ADDENDUM NO. 1

January 22, 2019

PROJECT: St. Paul Street Improvement Project
BID DUE DATE: **Revised to Monday, February 11, 2019 at 9:00 AM**
BIDDER QUESTIONS: **Revised to January 29, 2019 at 5:00 PM**
RESPONSES TO BIDDER QUESTIONS: To be posted on city website by 5:00 PM February 1, 2019
FROM: Nina Safavi, City of Burlington Parks, Recreation & Waterfront, Project Manager

Figure 1: Banner Orientation for Type P1 Poles

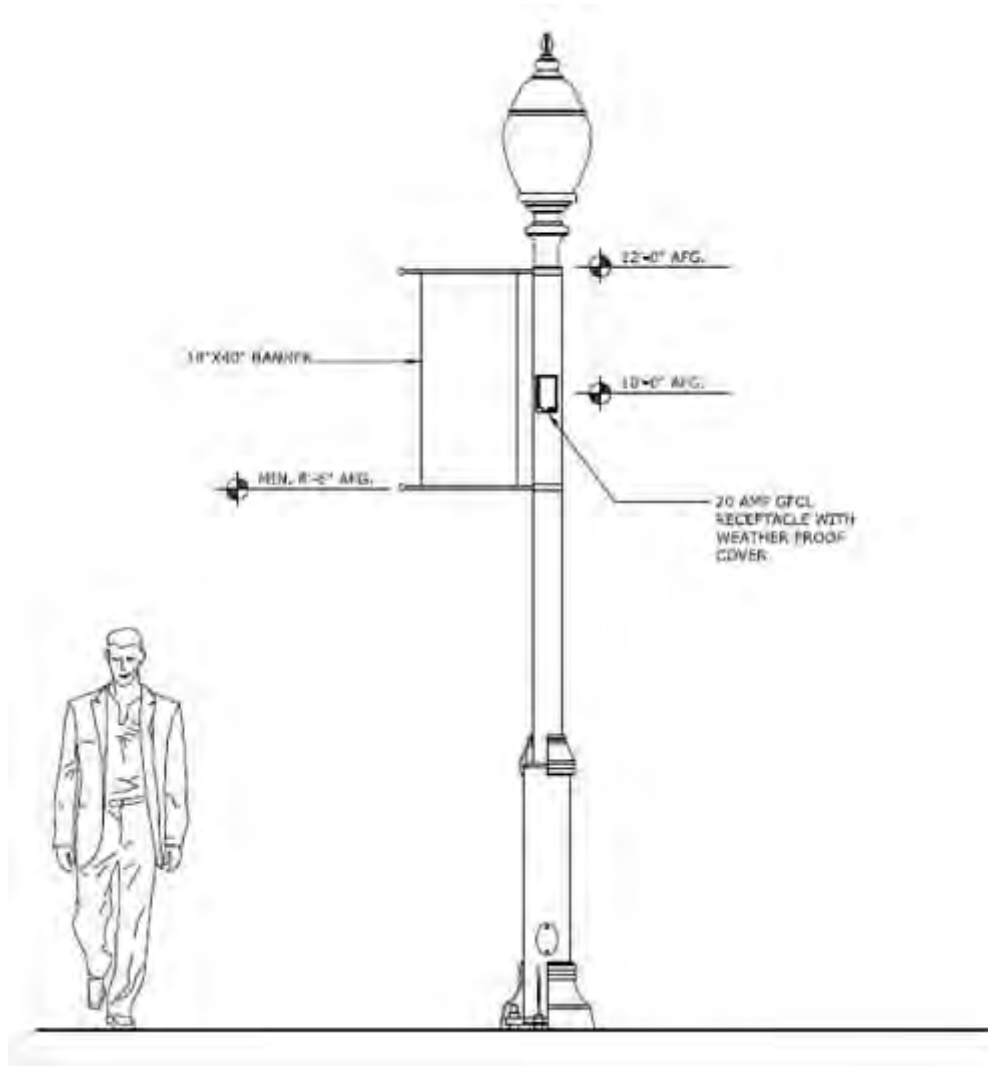
3. **APPENDICES:** The following has been added to the Contract Documents
- a. Figure 1: Banner Orientation for Type P1 Poles
 - b. Portland Loo Structural/Architectural Drawings
